Staff Report

Re: PLNPCM2022 - 00141 West Quarter Block C

Design Review

PROPERTY ADDRESS: 260 W 200 S **PARCEL ID:** 15-01-207-038-0000

LP101

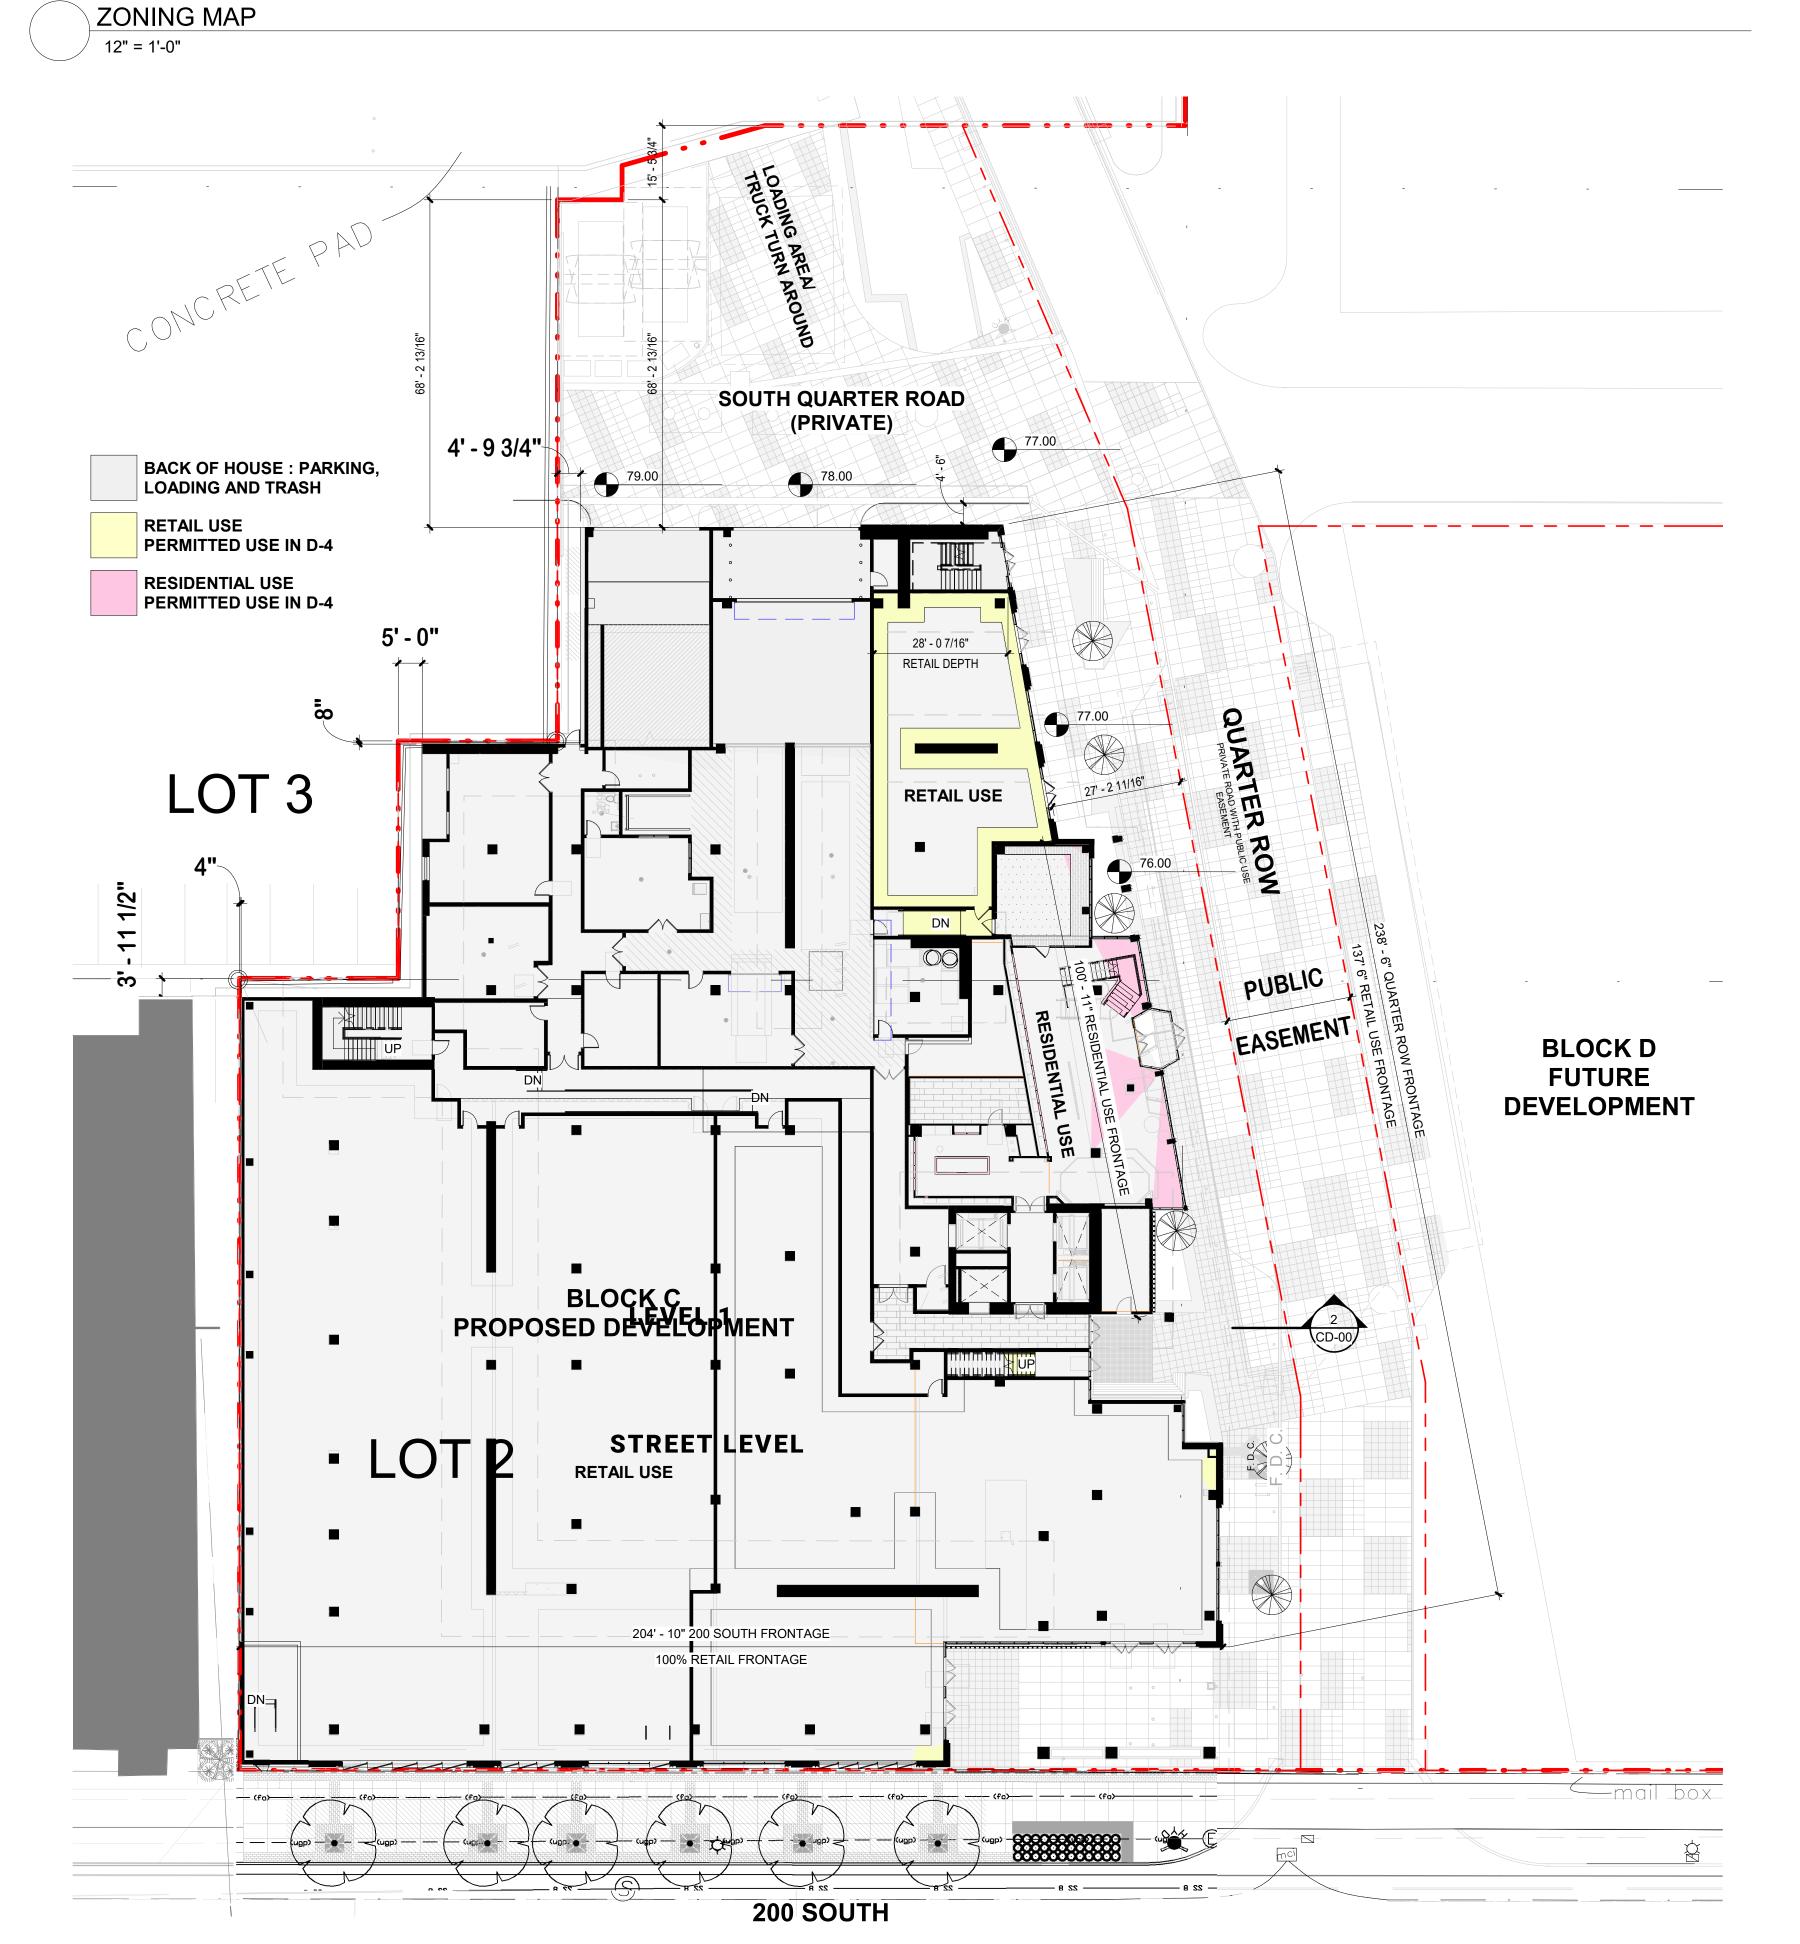
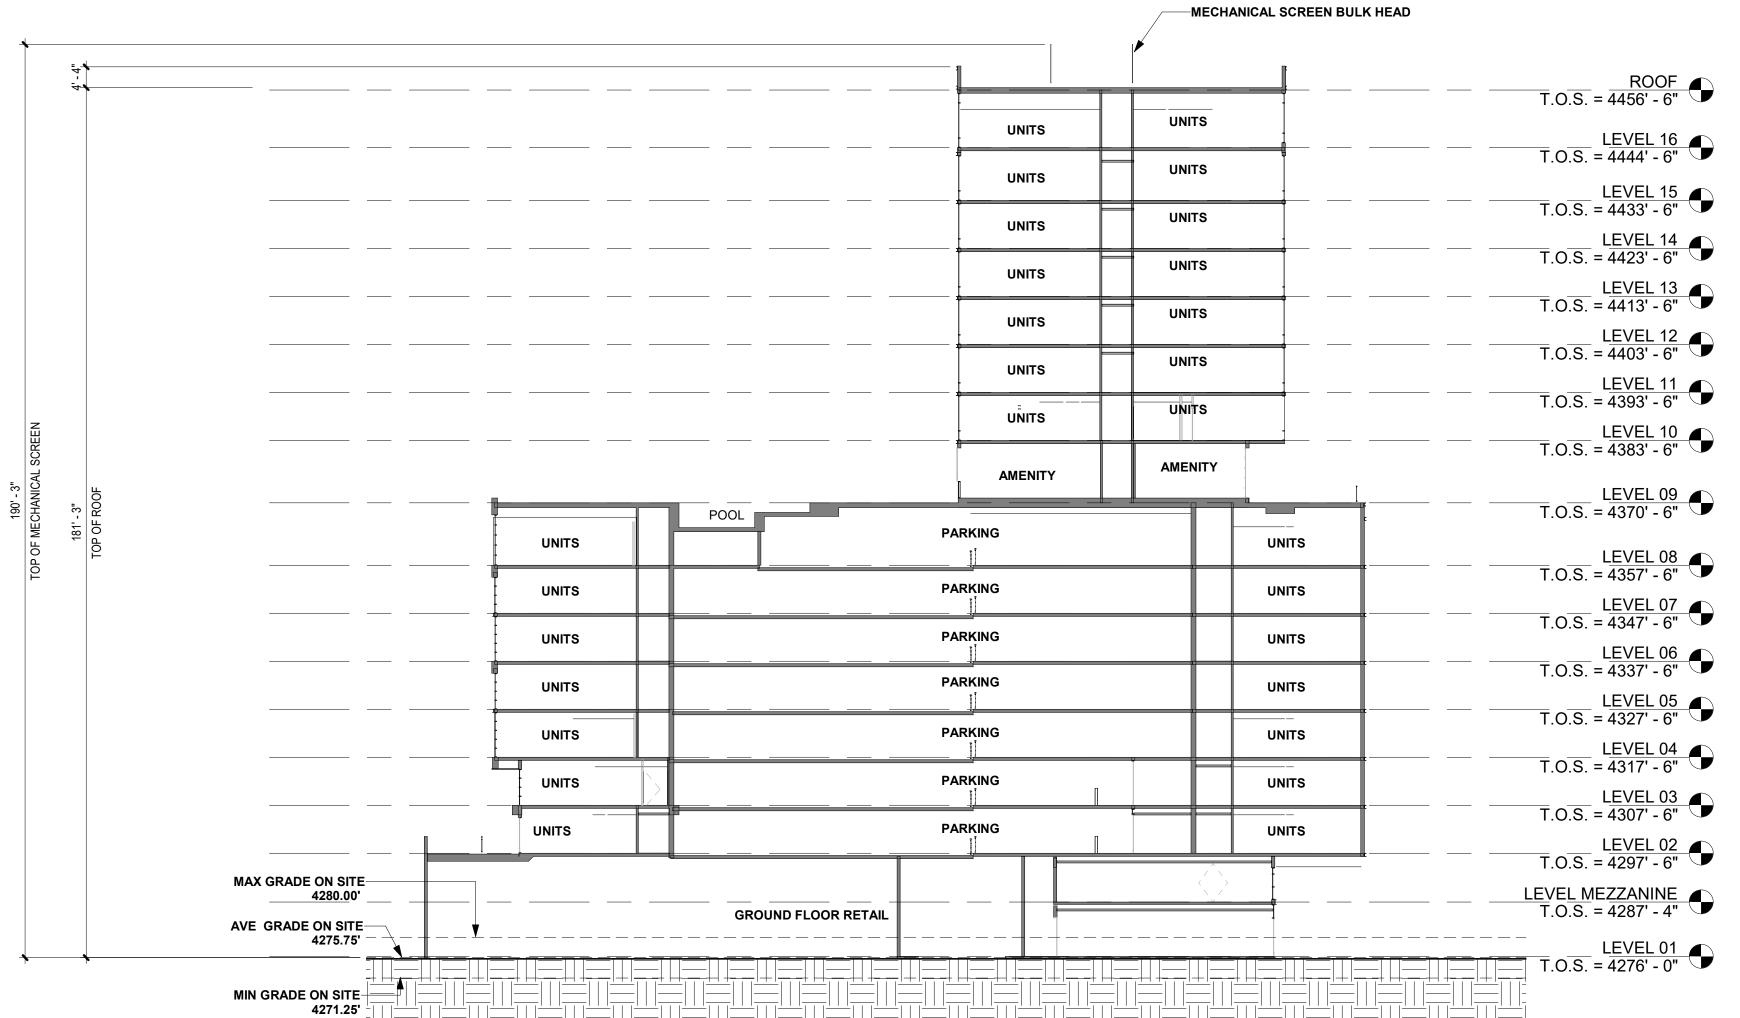
L.1: Number of trees is inconsistent on Pq LP101 and SP-01 please clarify. SP-01 should be updated to matchLP101.

The landscape plans still show a raised structure in the Right of Way. Structural encroachments such as raised planters are subject to additional department reviews and encroachment permits in compliance with section 21A.48.060.E.5 - See updated sheets LS101, LI101 and LP101 where we removed the raised planter and made it an at grade planter

Plant Hydrozones added to Plant Schedule on sheet LP101
